# Field Service Bulletin Trucks

SB-10052252-7963

Hood Shock Leaks CXU

## FSB 820-002, Hood Shock Leaks

W8082075

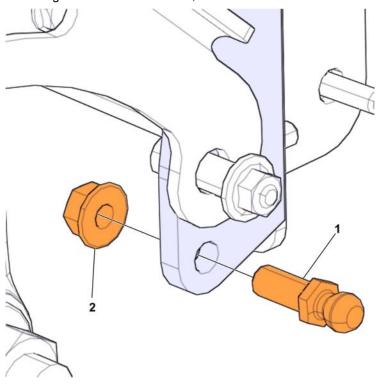
6 On the right hand side of the hood, remove the ball stud from the hood mounted bracket.

W8082076

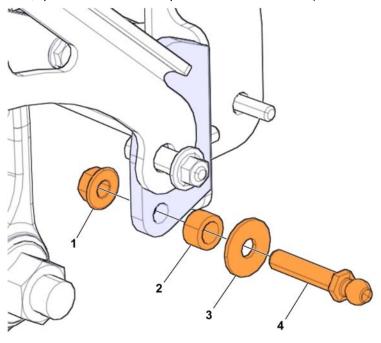
7 On the right hand side of the hood, at the hood mounted bracket, install the supplied ball stud, spacer and washer. Torque fastener to 48 ± 8 Nm (35.4 ± 6 ft-lb).

- 1 Lock Nut
- 2 Spacer (part number 994941) 3 Washer (part number 948823)
- 4 Ball Stud (part number 82058995)
- At the hood mounted bracket, using moderate pressure, push the shaft end of the shock onto the ball stud.
- 9 Install the body end of the shock on the frame (or radiator support) mounted ball stud.
